SUBJECT: **Scott's Seafood Restaurant, Jack London Square, Oakland, Alameda County**
(For Board consideration on April 6, 2015, Second Pre-Application Review)

**Scott's Restaurant
Jack London Square
Public Pavilion Modifications and
Public Access Enhancements**

SUBJECT: Approved Minutes of April 6 2015 BCDC Design Review Board Meeting

PAVILION FLOOR PLAN

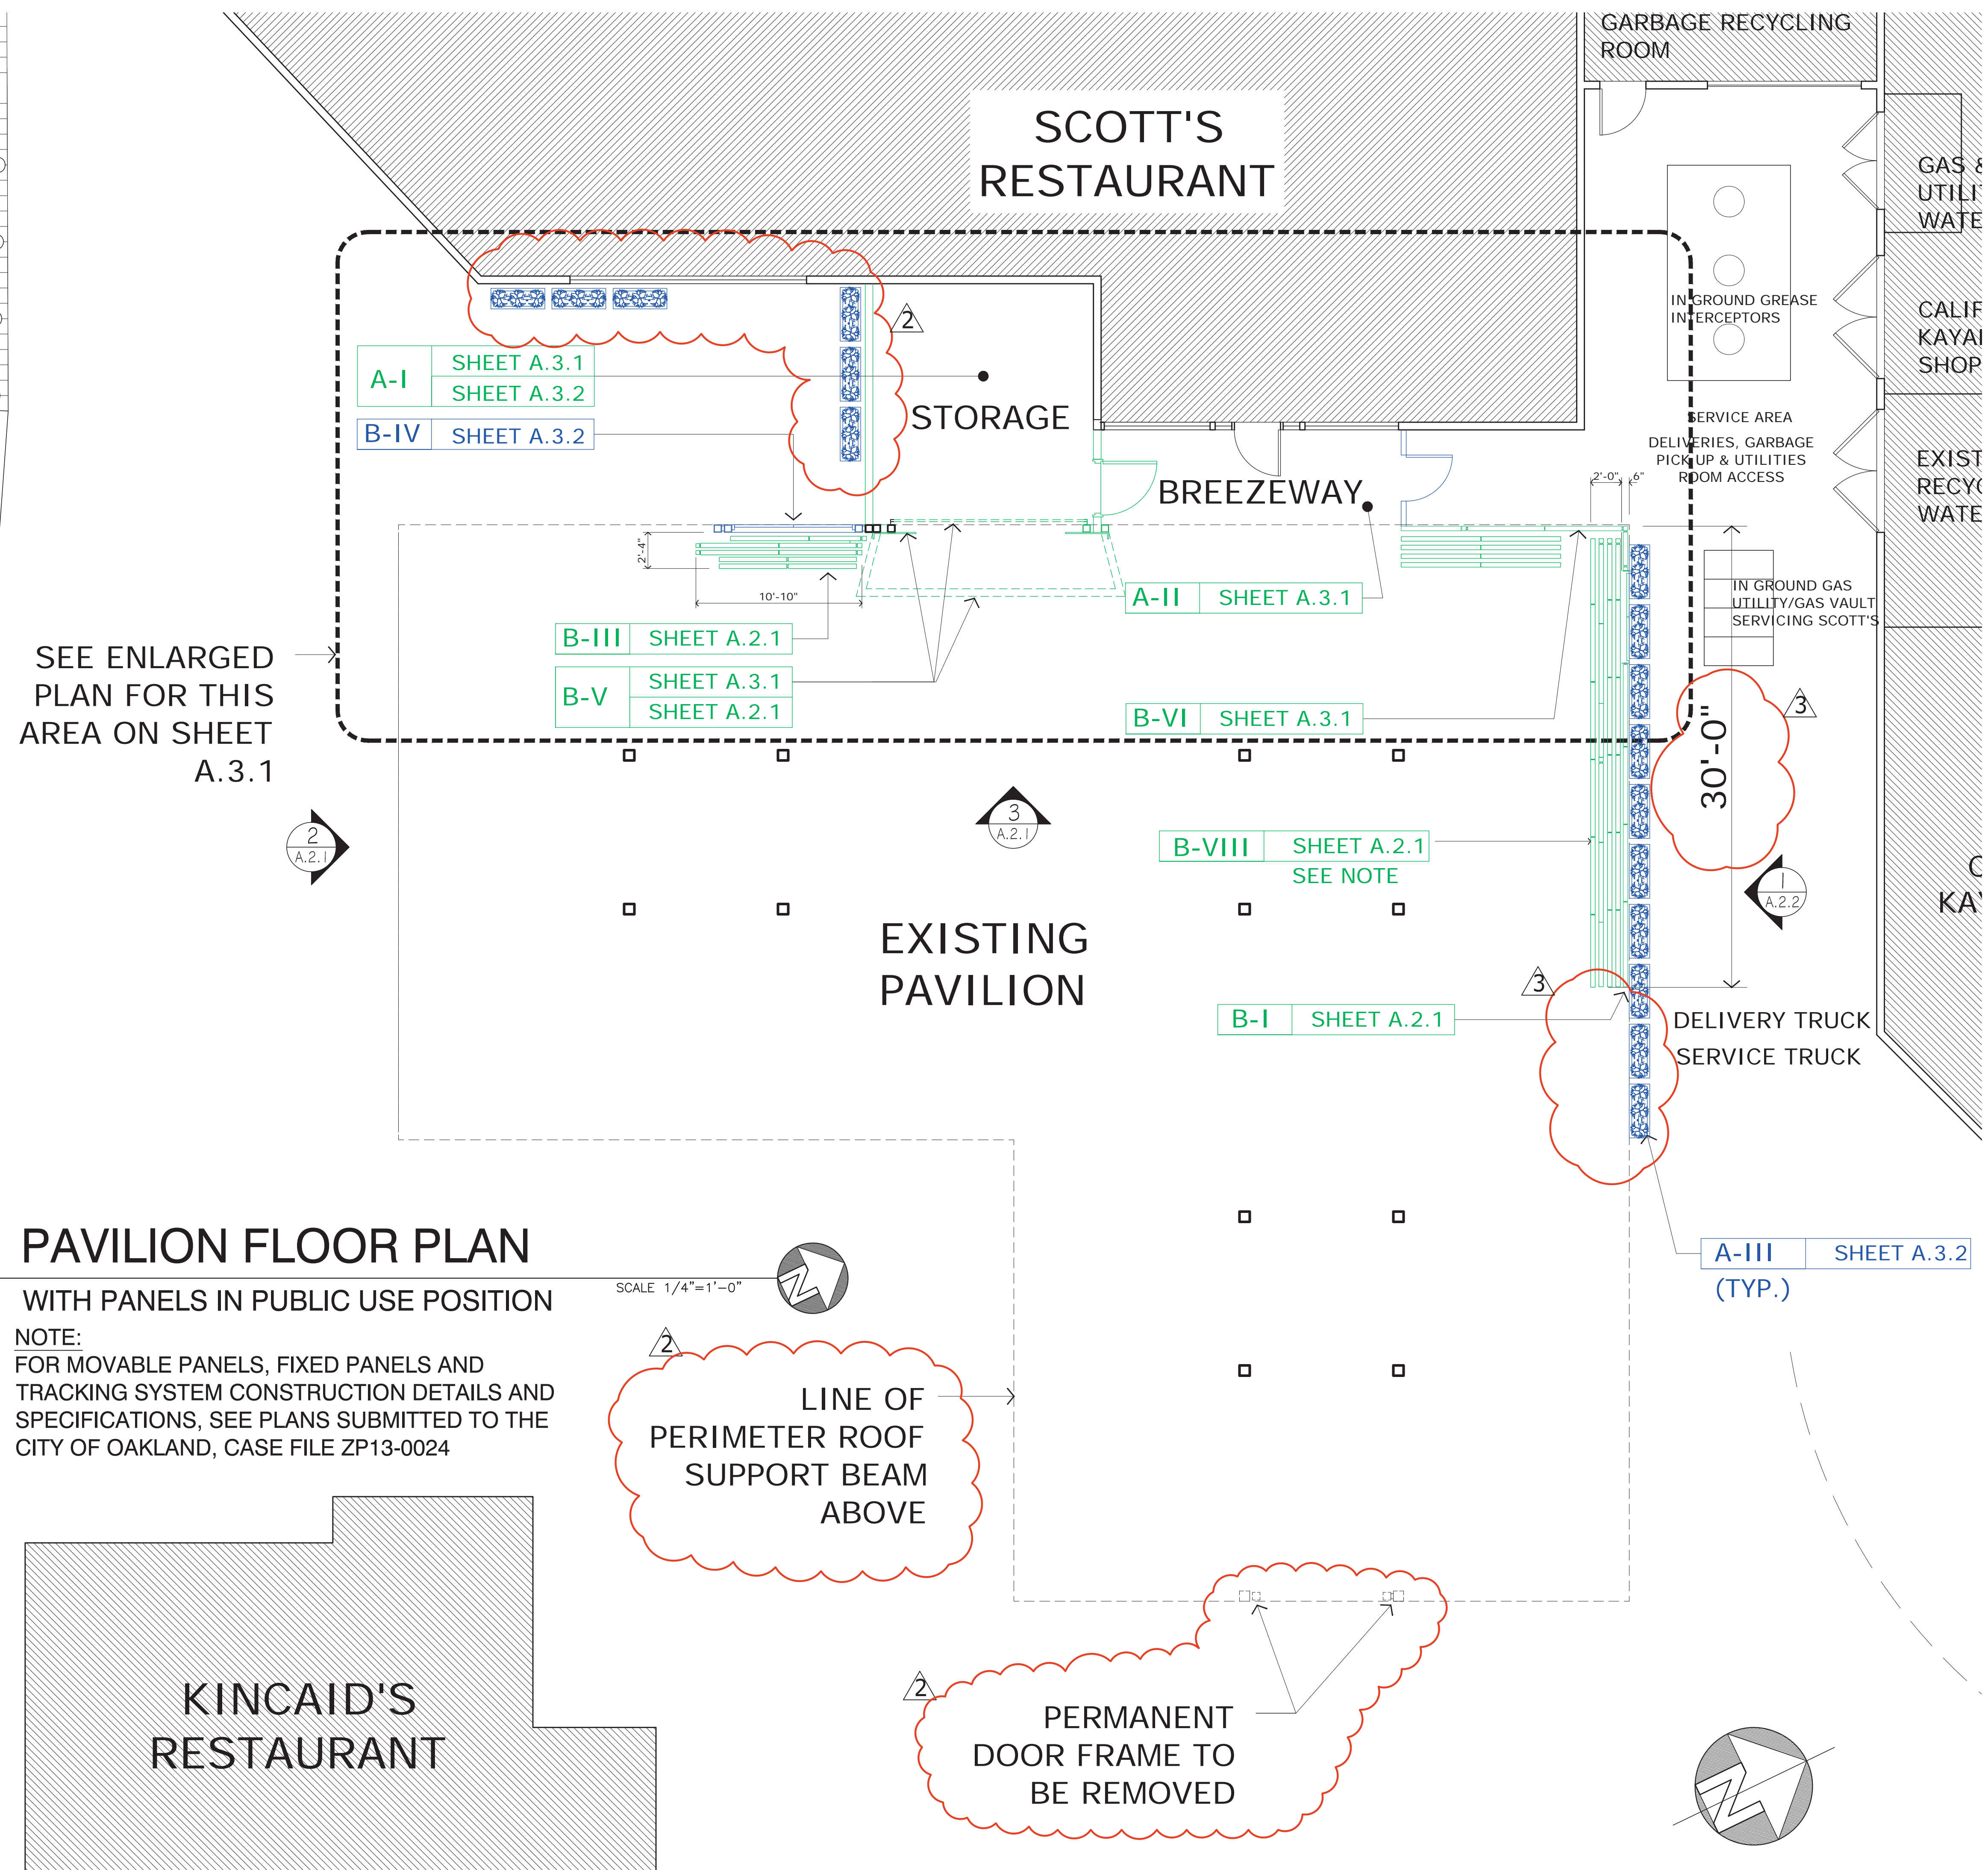
2. The Board determined that the permanent door structure on the east side of the pavilion should be removed from the proposal, in part, because it makes the public space feel private and creates a physical and visual obstruction.

Mr. Hirsch repeated his agreement with the proposed removal of the permanent doors from the east side of the pavilion. He also mentioned that the LED lights are not maritime in nature.

Applicants' Response: *The applicants are proposing to remove the permanent door structure currently in place on the east side of the pavilion. In order to provide the required exits on this side of the pavilion, they will instead install four additional movable wall panels that will have windows and exit doors inset within them.*

VIEW CORRIDOR PLAN
WITH PANELS IN PUBLIC USE
SCALE 1"=20'

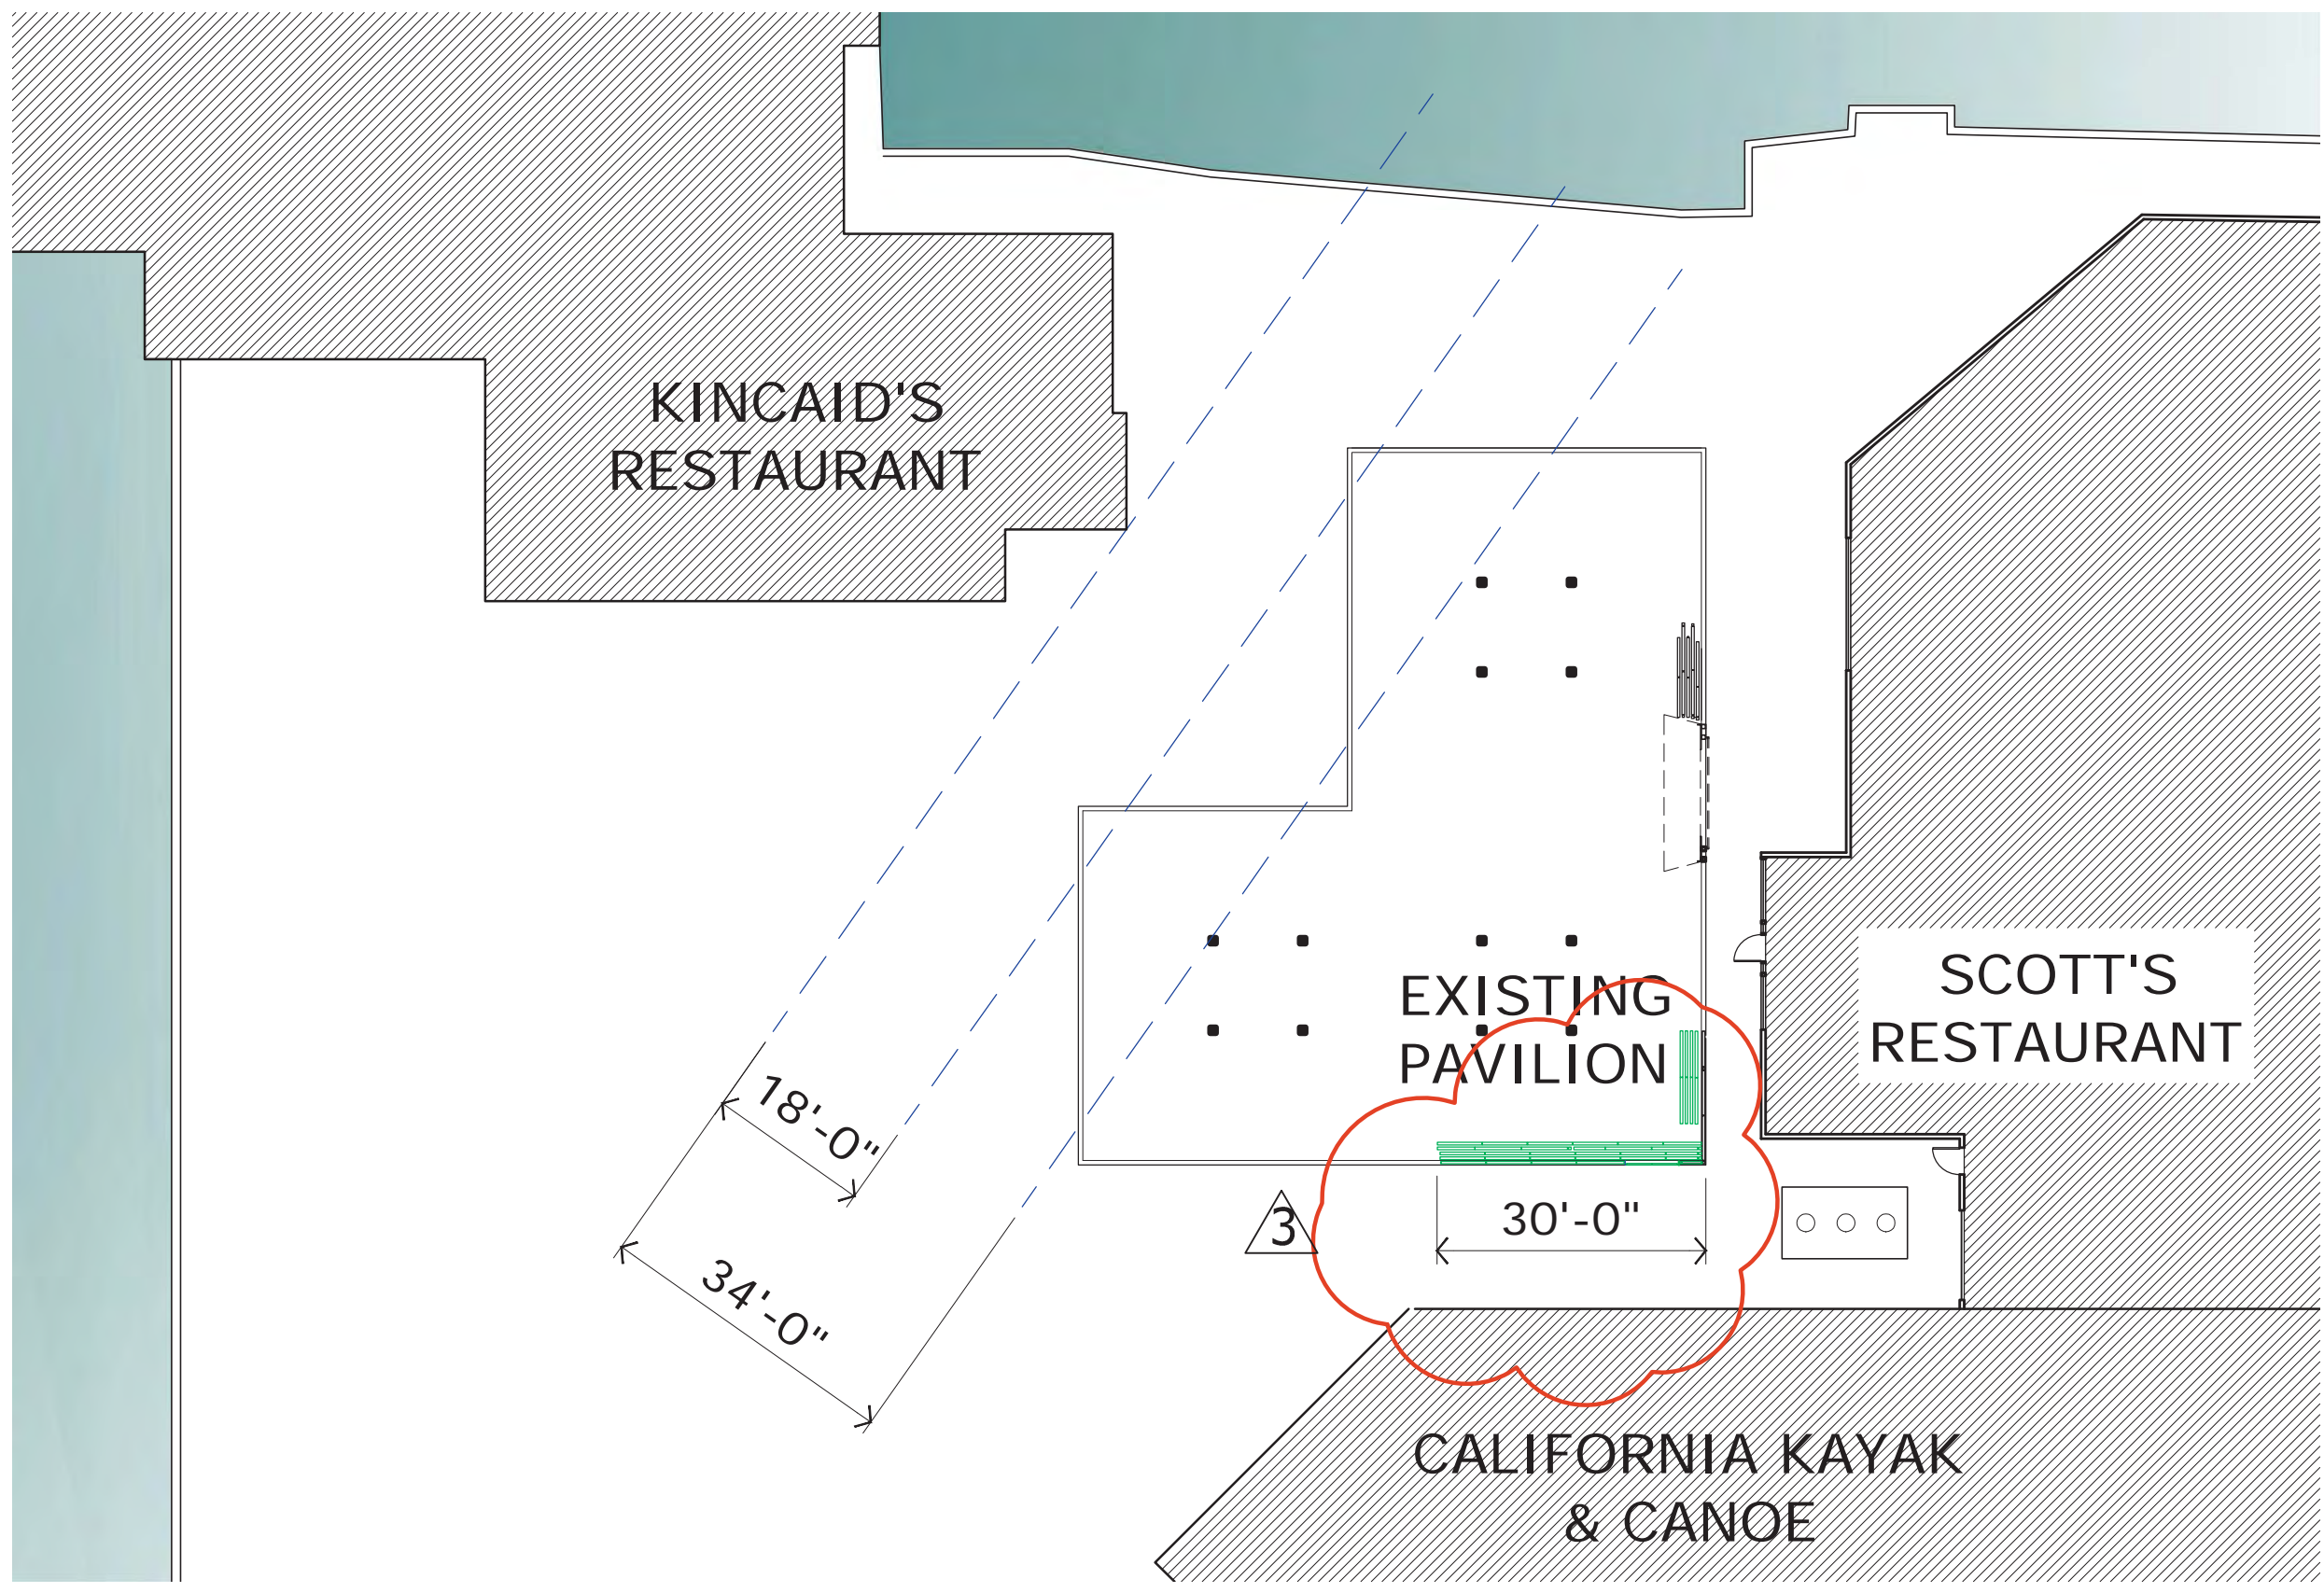
Sandy Threlfall, a member of Waterfront Action, commented that the Board had made good suggestions when they had reviewed the project a year ago. She stated that the view corridor shown on Sheet A.2.2 should remain open and not be blocked by trees as shown in the public access proposal. She noted that she likes the neon sign on top of the pavilion and recommended that neon signs at a lower level may be helpful. She believes the planters proposed for placement around the pavilion should not be used as they create barriers to public movement. She questioned that if the planters are there to protect the pavilion from being hit by trucks, then why would there be a need to have planters on the west side of the pavilion as shown in the drawings.
